Item Name: AS350/AS355 Quick Release Heli-Utility-Basket™ Long, Heavy Duty Lid

DART SERVICE INSTRUCTION

TO AMEND INSTALLATION INSTRUCTIONS D350-607-3 Rev.D,
INSTALLATION INSTRUCTIONS D350-607-4 Rev. C AND
INSTRUCTIONS FOR CONTINUED AIRWORTHINESS ICA-D350-607 REV. 6
REF TCCA STC: SH94-14
REF FAA STC: SR00213NY
REF EASA STC: EASA.10016996
REF BRAZILIAN STC: 2007S03-03/-04/-05/-06

A	NEW ISSUE	AJS	14.05.16
REV.	DESCRIPTION	BY	DATE
DESIGN	AJS	DART AEROSPACE LTD HAWKESBURY, ONTARIO, CANADA	
DRAWN	AJS		
CHECKED		DRAWING NO.	REV. A
MFG. APPR.	N/A	DSI 9699	SHEET 1 OF 2
APPROVED		TITLE	SCALE
DE APPR.		LUG REPLACEMENT	NTS
DATE	14.05.16	COPYRIGHT © 2014 BY DART AEROSPACE LTD THIS DOCUMENT IS PRIVATE AND CONFIDENTIAL AND IS SUPPLIED ON THE EXPRESS CONDITION THAT IT IS NOT TO BE USED FOR ANY PURPOSE OR COPIED OR COMMUNICATED TO ANY OTHER PERSON WITHOUT WRITTEN PERMISSION FROM DART AEROSPACE LTD.

FIGURE 1: INSTALLATION OF D4775-041 FWD STRUT

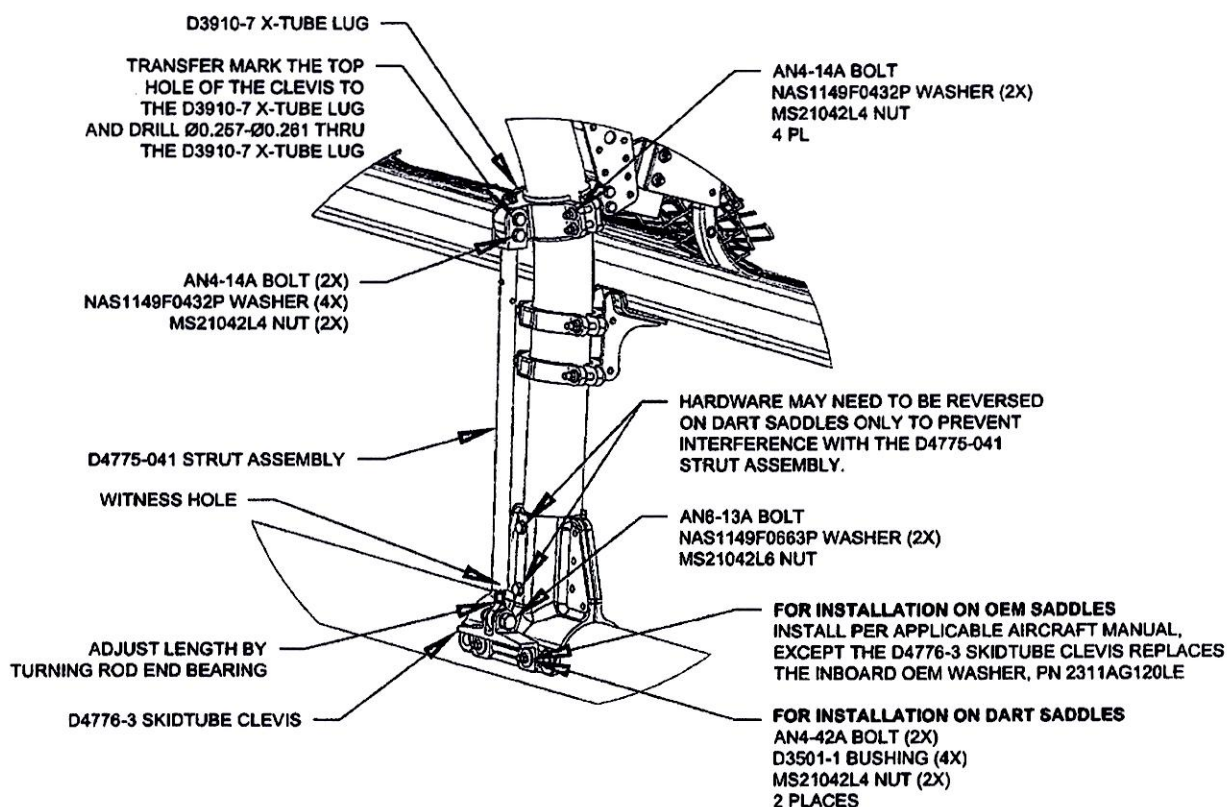
- 3.1 Substitute the Forward Lower D3910-5 X-Tube Lug with the D3910-7 X-Tube Lug as shown in Figure 1.
- 3.2 Install the forward D4775-041 Strut Assembly. Transfer mark from the upper hole on the clevis of the D4775-041 Strut Assembly to the D3910-7 X-tube Lug and drill thru the lug $\varnothing 0.257$ - $\varnothing 0.261$ as shown in Figure 1. Touch up chemical conversion coating per MIL-DTL-5541. Check the witness holes located at the bottom end of the D4775-041 Strut Assemblies to ensure that the thread from the rod end extends past the witness hole.
Torque MS21042L4/-4 nuts to 50-70 in-lbs (5.7-7.9 N-m). Torque MS21042L6/-6 nuts to 160-190 in-lbs (18.1-21.5 N-m).
- 3.3 Complete the installation in accordance with Installation Instructions D350-607-3 Rev. D or D350-607-4 Rev. C.
